Application 3/2023/0866 - Land adjacent to 9 Old Road Chatburn BB7 4AB

Please find below comments and representations on Application 3/2023/0866 - Land adjacent to 9 Old Road Chatburn BB7 4AB.

Drawing 23 0866 Segregated Topo and Sections Rev J 7feb24

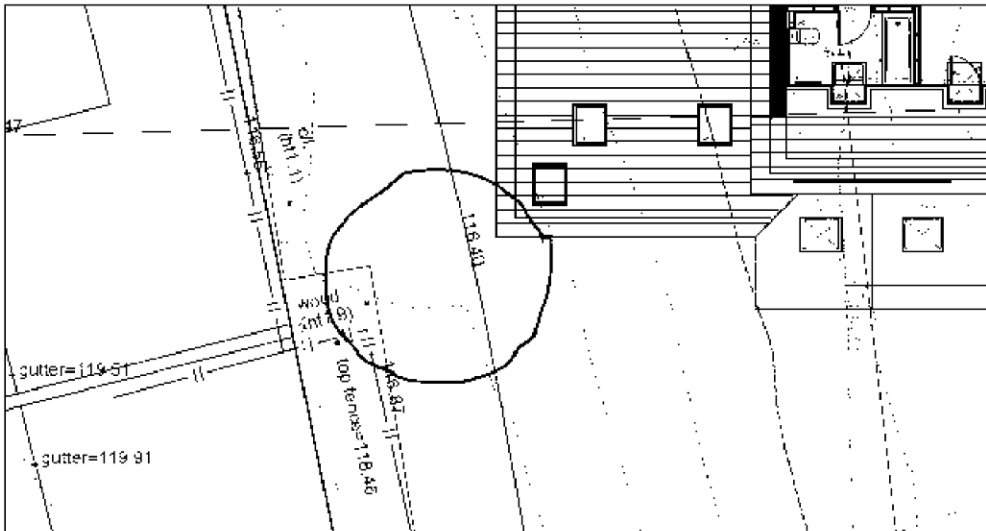
*Extract from submitted drawing. Critical proximity point is as above red circle location.*

Section ref. 'x-sec 11' shows a proposed 1.8m retaining wall immediately in front of the land (existing fence line) boundaries of No.1 & 2 Hare Hill Croft (HHC).

The existing ground level at the NE corner fence line of No.2 HHC is 116.87 from the topographical details provided and the FFL of the proposed dwelling is 113.85. The level difference between these two points is therefore 3.02m. The plan distance from the NE fence line corner of No.2 HHC to the SW corner of the proposed dwelling is c. 3m. The actual depth of excavation required for both foundations and retaining wall will inevitably be below FFL ie greater than 3.02m. A 1.8m retaining wall is insufficient and the location of the current cross section and way it is drawn oversimplifies the issue.

From earlier comments I have queried the engineering qualities and specification for the original placement of the existing bulk fill that was imported during the HHC construction. These details need to be known in order to design and assess any retaining wall options.

In addition, the location of the proposed retaining wall is close to the existing boundaries of No's 1 & 2 HHC which inevitably means an easement into the gardens of No's 1&2 HHC would be required to facilitate construction of the

proposed retaining wall. The authority should seek full details of the proposed structure and its method of construction to be satisfied that the proposals will not adversely affect the HHC properties.

Drawing 23\_0866 Landscape Strategy RevC 7feb24

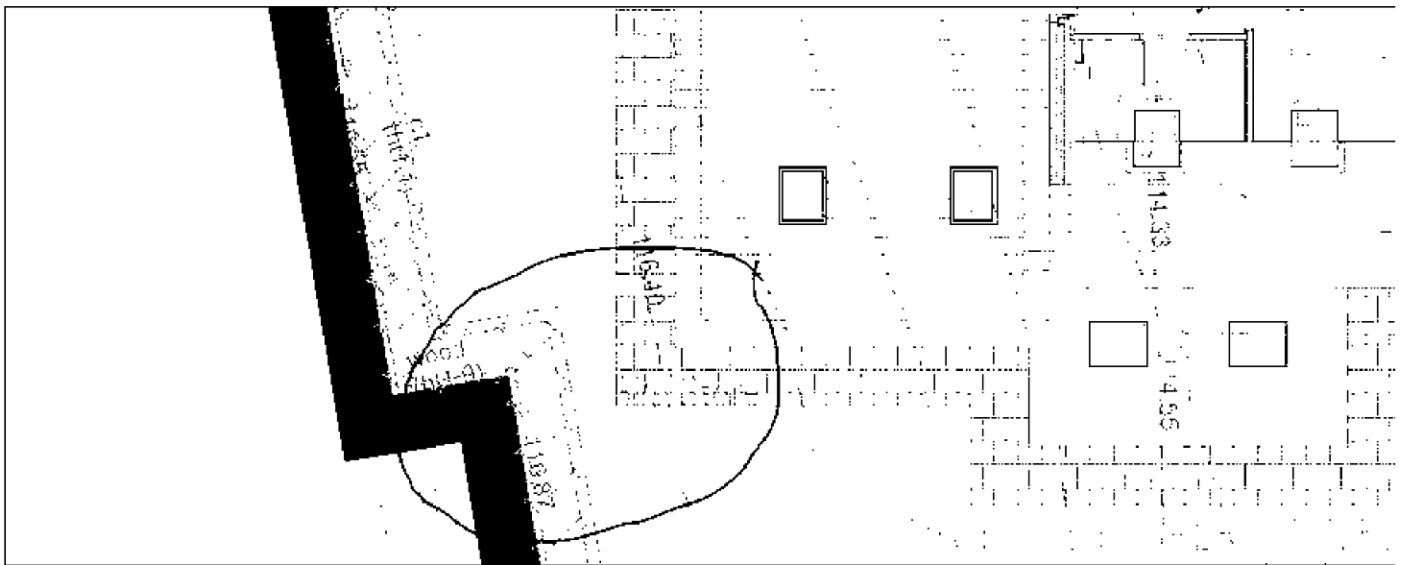
Extract from this drawing (below) shows the proposed landscape details. Planting is shown at high level as well as a low-level path around the property at ground floor level. A 1.8m high timber fence detail is provided (Drawing 23\_0866\_Boundary\_Fence\_Wall\_Details\_7feb24) which imposes significant wind loading on the retaining wall structure. All of these points suggest the details as submitted will not be buildable without encroaching into the HHC properties gardens.
